PIC18F6627/6722/8627/8722

PIC18F6627/6722/8627/8722 Rev. A1 Silicon Errata

FIGURE 1: SCKx PULSE VARIATION USING TIMER2/2

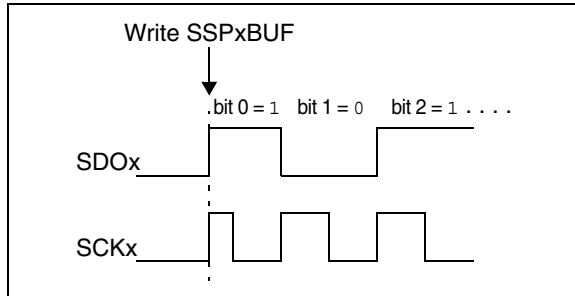
When the SPI is using Timer2/2 as the clock source, a shorter than expected SCKx pulse may occur on the first bit of the transmitted/received data (Figure 1).

To avoid producing the short pulse, turn off Timer2 and clear the TMR2 register, load the SSPxBUF with the data to transmit and then turn Timer2 back on. Refer to Example 4 for sample code.
